November 15, 2016 GH17563-G

Subject: Response to City Correction Letter and Revised Basement Wall Designs,

1830 N. Blue Heights Drive, Los Angeles, California.

#### GEOLOGY AND SOILS REPORT CORRECTION LETTER

1830 N. Blue Heights Drive Los Angeles, California GEOLOGIC SECTION B

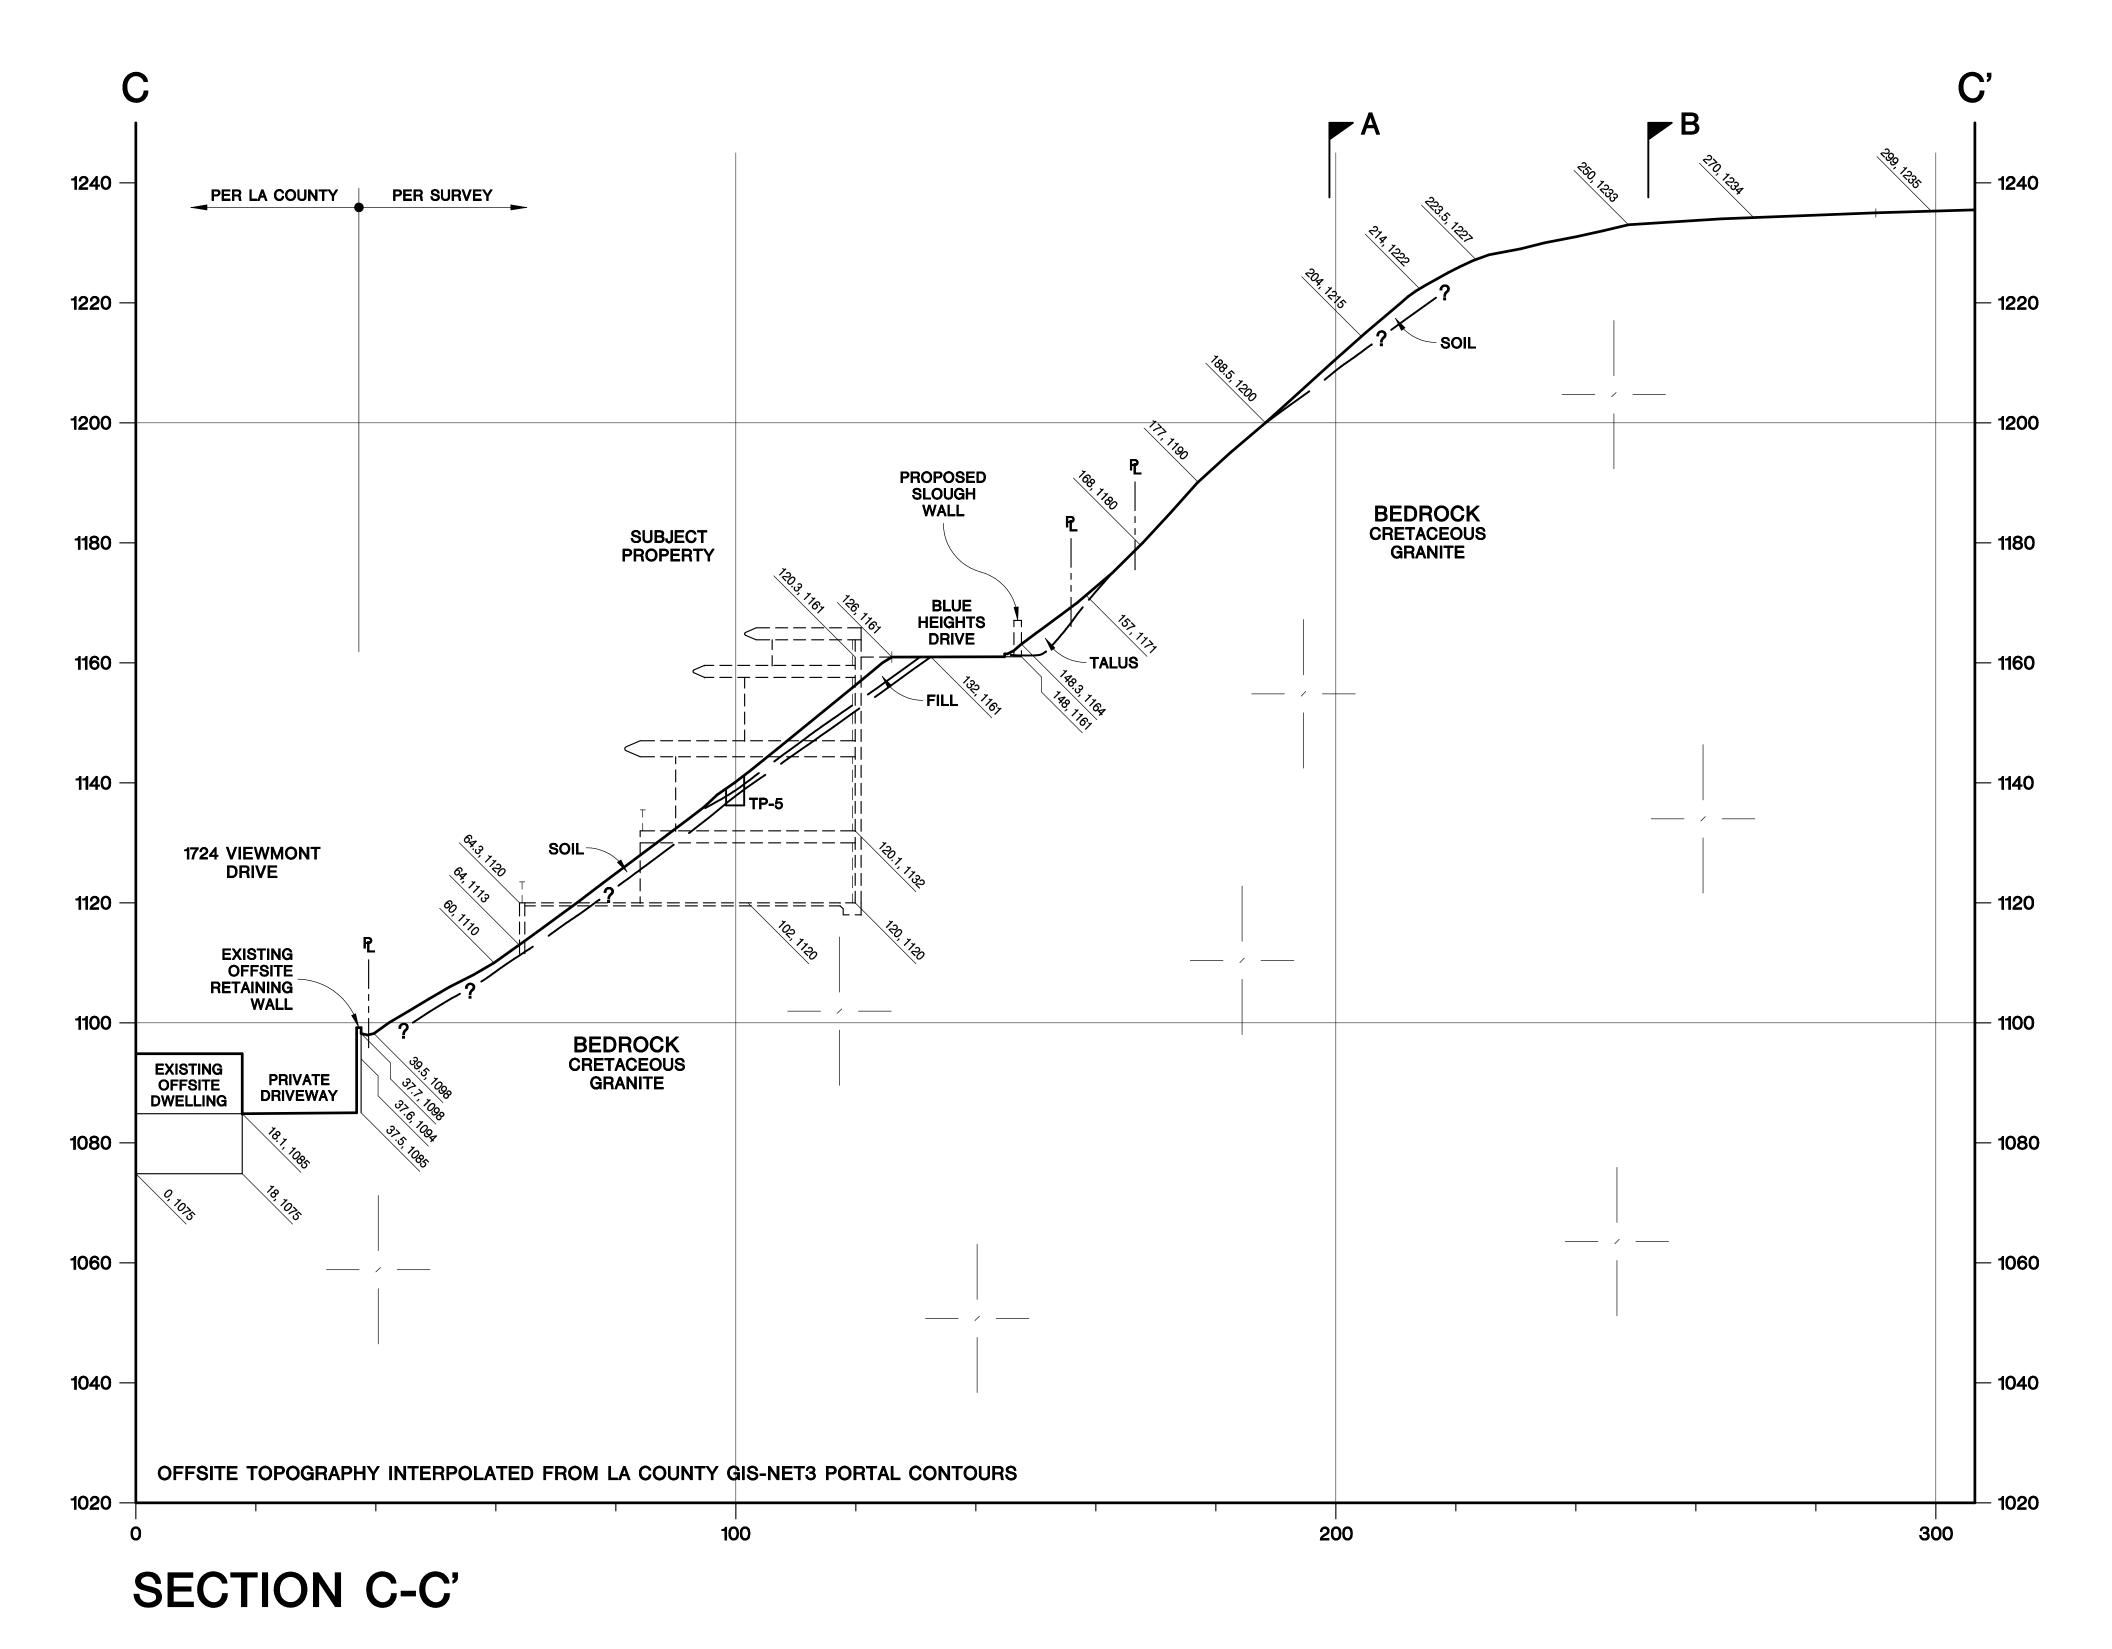
Item 4: Identify all non-conforming conditions and provide recommendations to bring the entire site into conformance with the current Code standard (7005.9). As described in the text of the referenced report, cut slopes were excavated on the subject site to lower the height of the existing offsite walls to the south and west. Show the location of all existing cut slopes on the geologic map and cross sections and determine if they are currently code conforming.

**Item 5:** As depicted in sections A and B, it does not appear that the proposed residence and bowling alley have the required building setbacks for slopes steeper than 1:1 from the plane drawn tangent to the slope at an angle of 45 degrees to the horizontal. Provide recommendations and revise the plan(s) and cross section(s) for providing the required building setback from the toe of the ascending slope as specified by Code Section 1808.7.1.

**Response:** The area of the apparent cut slope is shown on Section B. The cut conforms with the allowable slope gradient. We believe that the other areas where bedrock is exposed are natural outcrops and not the result of grading for offsite retaining walls. The only other non-conforming condition is the presence of cast fill near the street. That fill should be removed and recompacted upslope of the planned retaining walls and should be removed from the slope downslope of those walls.

**Response:** The over-steepened cut slope above Blue Heights Drive will be trimmed to a 1:1 gradient as shown on sections A, B and D. Therefore, the building will have the required setback to the ascending slope. The slope trimming has been agreed to by the offsite property owner.

# 1830 N. Blue Heights Drive Los Angeles, California GEOLOGIC SECTION D

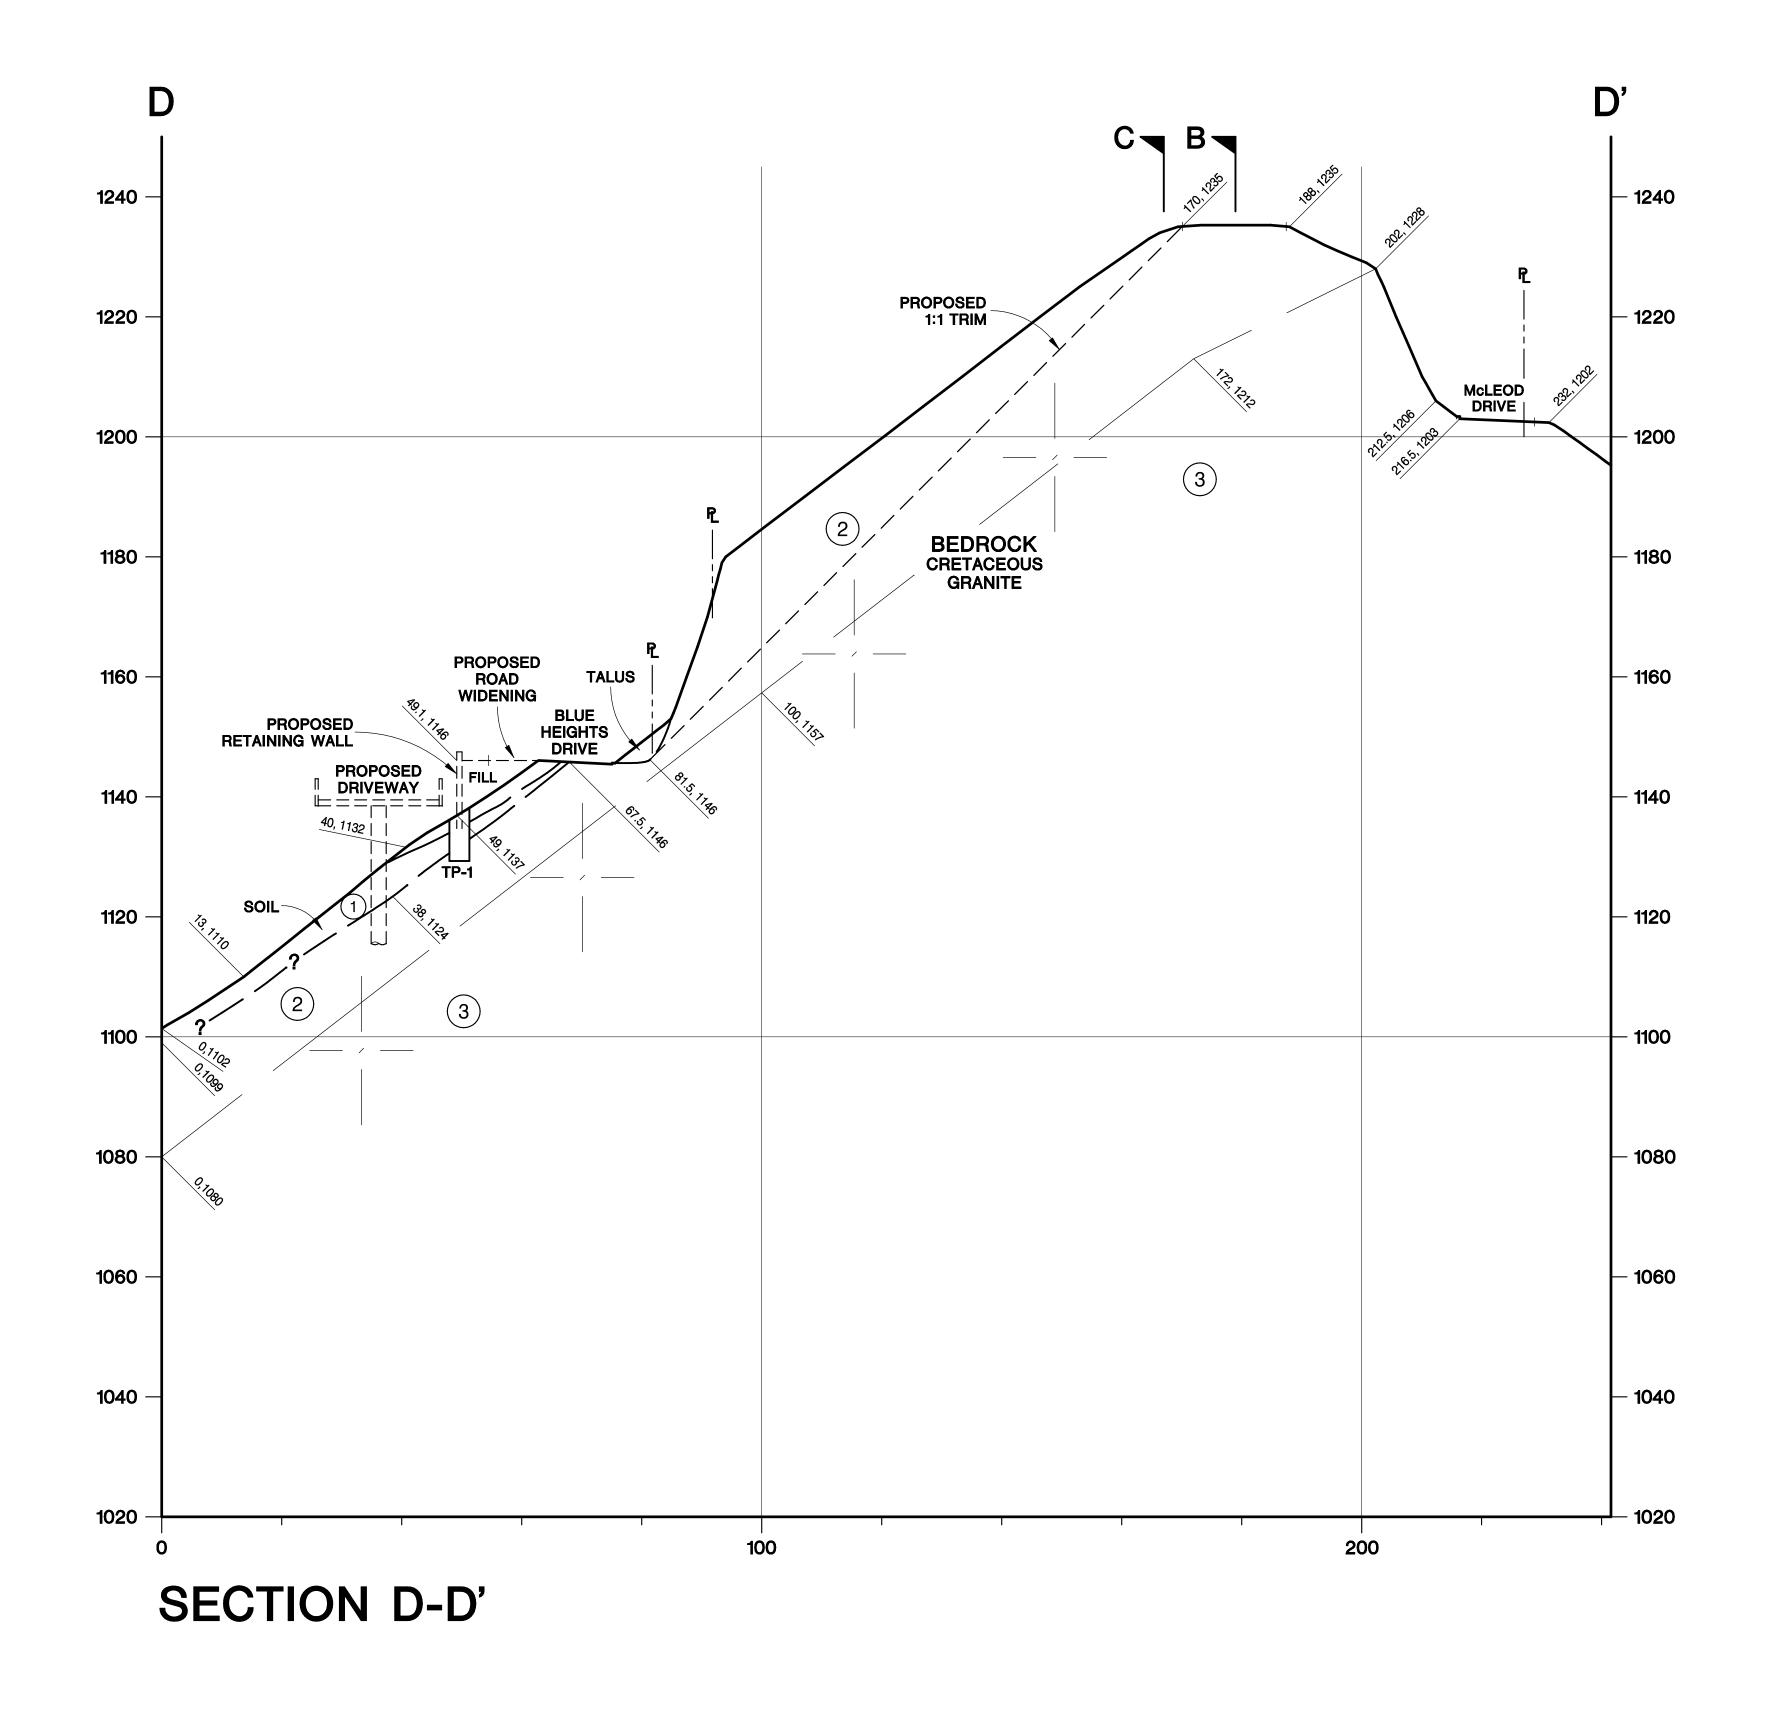
Item 3: Provide additional geological cross sections illustrating existing and proposed grades and structures along the entire length of the proposed private road improvements to demonstrate safe and stable access. Please clarify the meaning of the notes indicating approximate height upslope of Blue Heights Drive (approx. Vertical height, approx. cut slope height, etc.?) Why wasn't the slope area with "Approx. 30' High" analyzed as the highest slope height?

**Response:** We have prepared Section D to depict conditions above the northern portion of the planned development. We currently anticipate that the 1:1 trim above or east of Blue Heights Drive will be extended north of the site along the private street. As discussed above, a separate private street report will be issued once the plan is complete. A stability analysis for Section D is included.

XSTABL File: 17563A4S 11-10-16 15:34

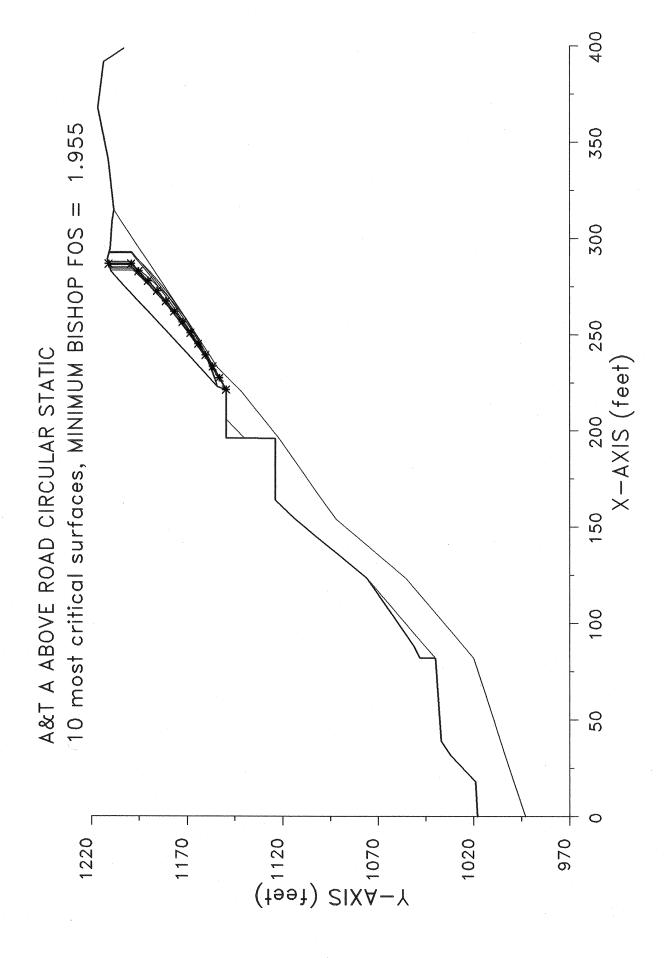
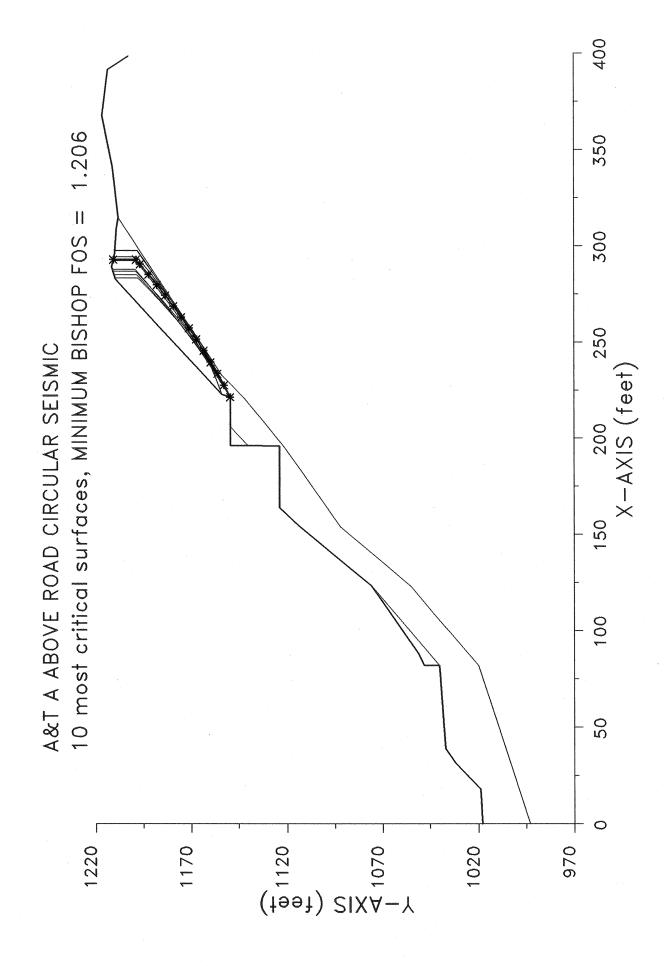
*Item 6:* Provide a stability evaluation for the slopes above and below the proposed private roadway improvements.

**Response:** We have revised sections A and B to reflect the trim above the roadway and have created Section D. The stability analyses provided in XSTABL files 17563A4, 17563A4S, 17563B4. 17563B48, 17563D1, 17563D1S, 17563D2 and 17563D2S indicate that the trimmed cut slope above Blue Heights Drive will have the required safety factor. We previously analyzed the slope below the road and the planned trim reduces the overall steepness of the entire slope.

XSTABL File: 17563A6 11-11-16 11:00

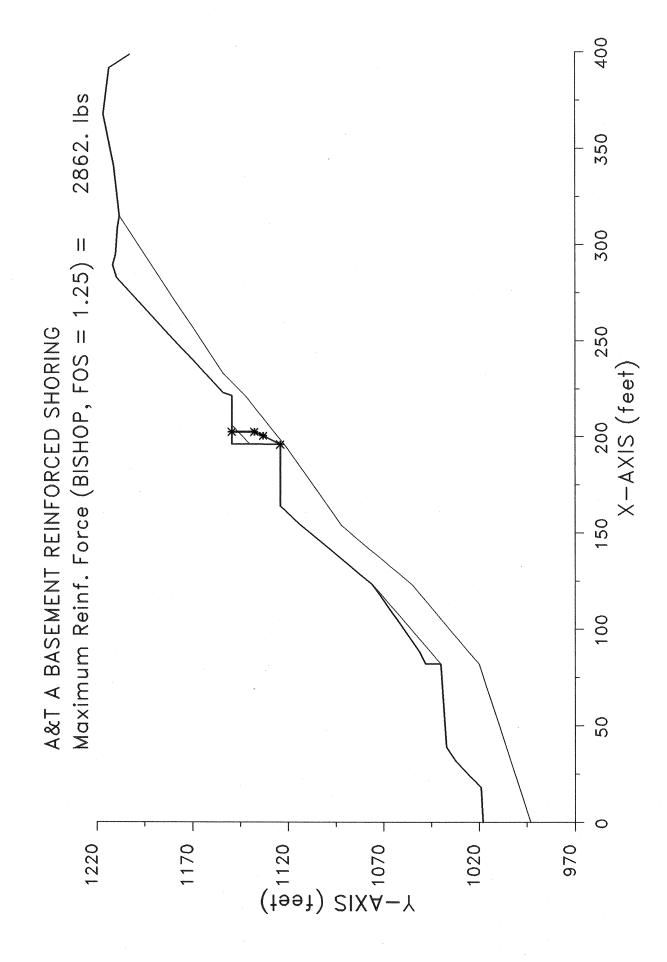
*Item 8:* Provide complete recommendations for temporary shoring and basement retaining walls to include surcharge pressures from the cut slopes above Blue Heights Drive.

**Response:** Analyses along sections A and B for the highest walls indicate that the trimmed cut slope above Blue Heights Drive does not surcharge the shoring (XSTABL File 17563A6 and 17563B5).
